UN#12-067

Subject: UniStar Nuclear Energy, NRC Docket No. 52-016
Correction of Final Safety Analysis Report (FSAR) Figure 8.3-1
in Calvert Cliffs Nuclear Power Plant, Unit 3, Combined
License Application (COLA) Revision 8

**Correction of Final Safety Analysis Report (FSAR) Figure 8.3-1,
COLA Revision 8, Calvert Cliffs Nuclear Power Plant, Unit 3**

Figure 8.3-1 — (CCNPP Unit 3 Emergency Power Supply System Single Line Drawing)
(Page 1 of 3)

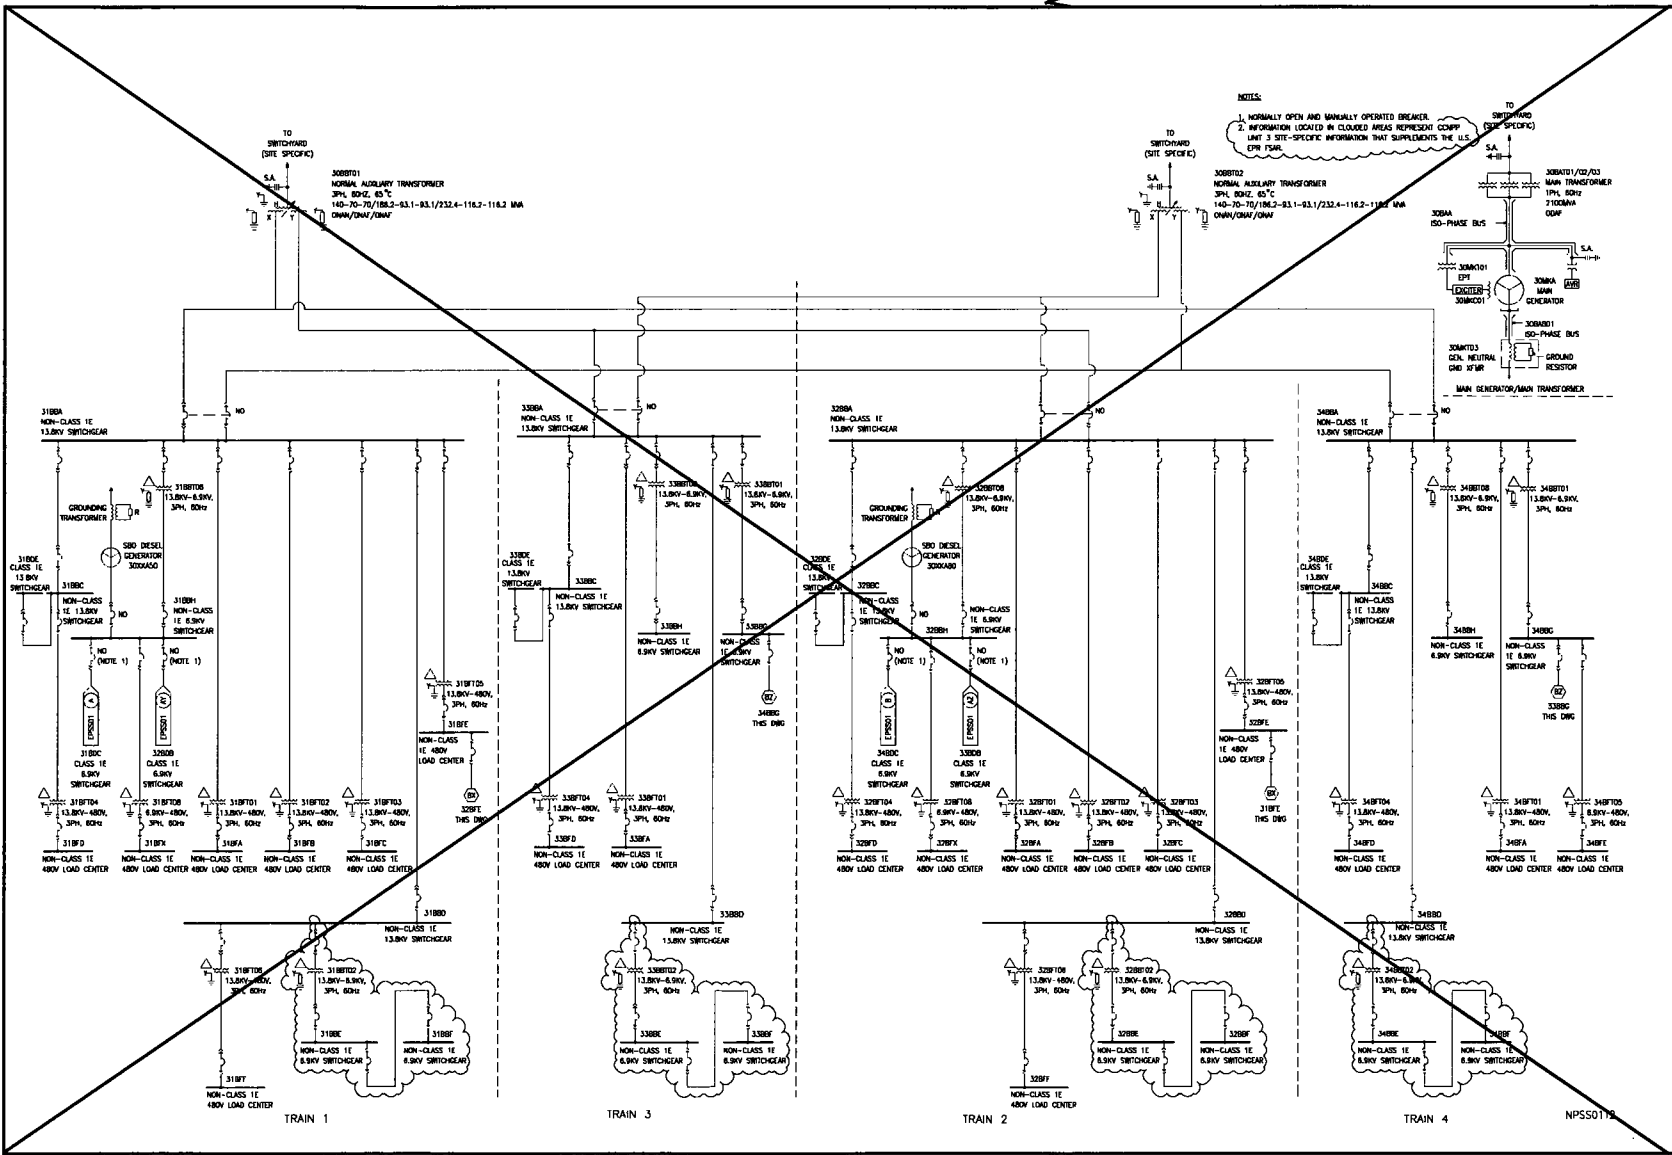
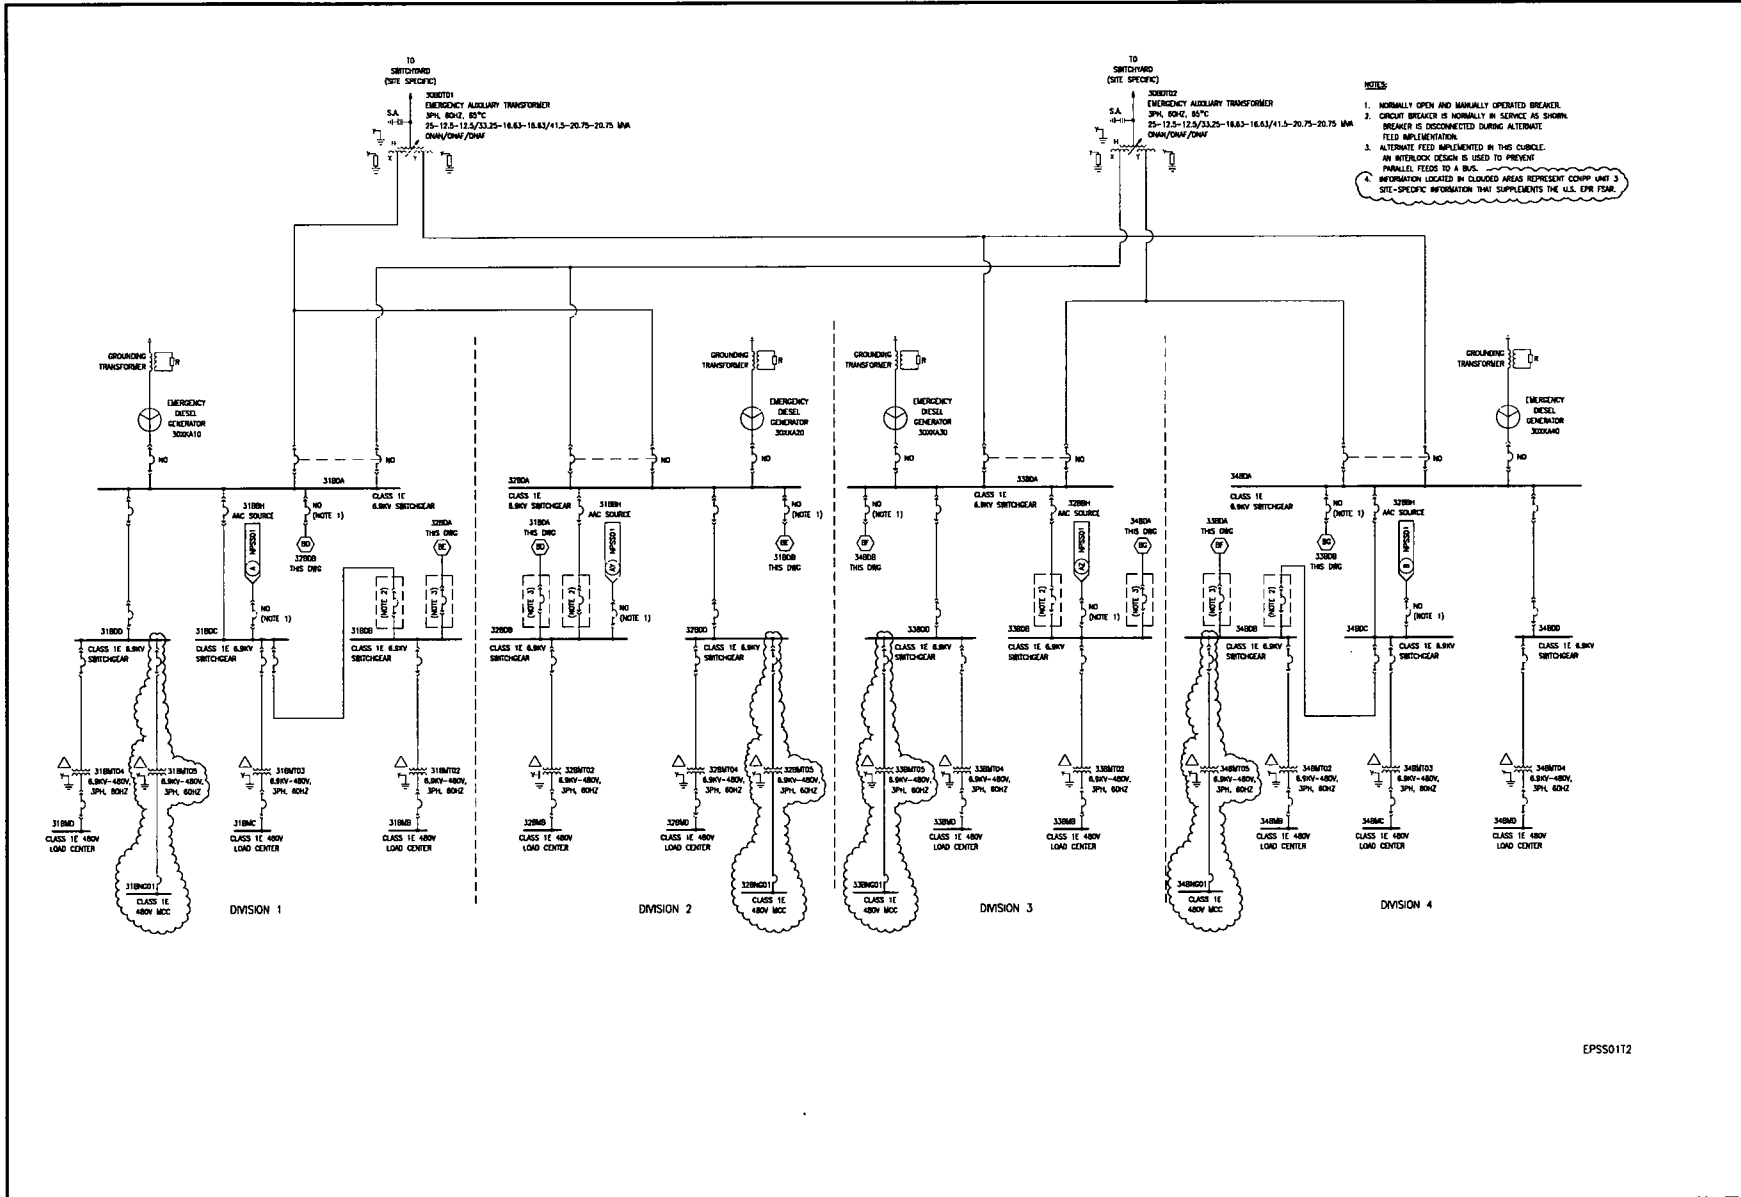
The purpose of this letter is to provide a correction to Final Safety Analysis Report (FSAR) Figure 8.3-1 as presented in Calvert Cliffs Nuclear Power Plant (CCNPP), Unit 3, Combined License Application (COLA) Revision 8 (Reference 2). In a call with the CCNPP NRC Project Manager, UniStar Nuclear Energy (UNE) was questioned why FSAR Figure 8.3-1 was revised in COLA Revision 8. The revised Figure 8.3-1 was incorrect.

Initial investigation into this condition revealed that COLA Revision 8 changes were required to subsequent FSAR Figure 8.3-2 (Pages 1, 3, and 5 of 5). However, in COLA processing, FSAR Figure 8.3-1 (Pages 1 through 3) were also inadvertently replaced with the duplicate FSAR

Figure 8.3-2 pages (Pages 1, 3, and 5 of 5). A condition report regarding the incorrect FSAR Figure 8.3-1 revision in COLA Revision 8 has been entered into the UNE corrective action program for disposition.

FSAR Figure 8.3-1 should not have been revised in COLA Revision 8. FSAR Figure 8.3-1, as shown in COLA Revision 7 (Reference 1), remains correct. The enclosure to this letter provides a markup of the correction which is being made to FSAR Figure 8.3-1 to restore the correct figure. A Licensing Basis Document Change Request has been initiated to incorporate these changes into a future revision of the COLA.

Insert 1

Insert 1
